ONE ~ GIRDER ~ 7G2B

____ APPROVED
_X_ APPROVED AS NOTED
____ REVISE AND RESUBMIT

STRUCTURE: BENMONT AVE. (TH-7) (URBAN MINOR ARTERIAL)
LOCATION: TOWN OF BENNINGTON, VERMONT
PROJECT NO.: BRIDGE NO. 57 PROJECT NO. BRF 1000(16)
ENGINEER: STATE OF VERMONT AGENCY OF TRANSPORTATION
CUSTOMER: ALPINE CONSTRUCTION
ITEM: GIRDER ~ 7G2B
SURFACE PREP.: SSPC-SP10 OPEN HOLES: 15/16⌀ (UN)
PAINT: NONE

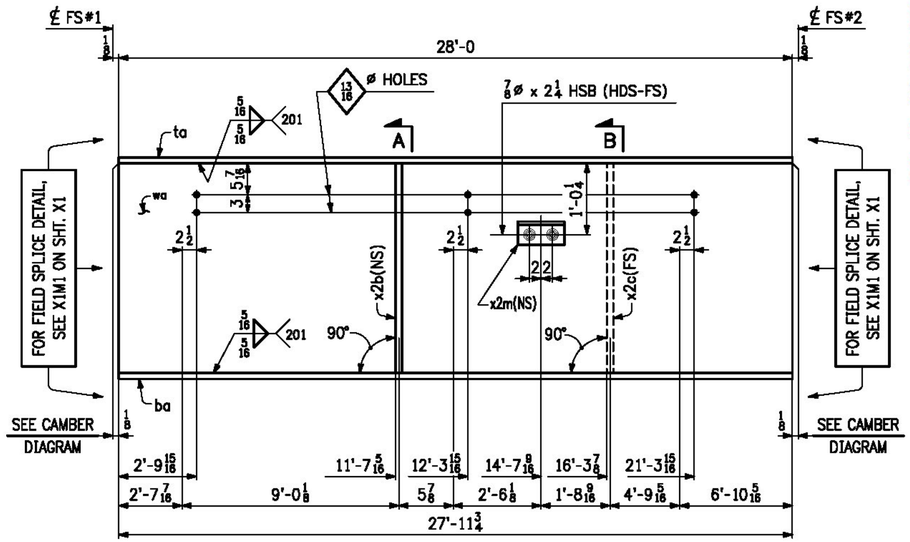
Spacing of waterline support beams are not all at 9'-0" spaces as shown on Contract Drawing Sheet 39 of 75. Maximum variation appears to be 9". The increase in span is acceptable, however the Contractor should refer to the Special Provision (Water Main on Bridge) to ensure compliance with the hanger distance to pipe joint requirements are also met.
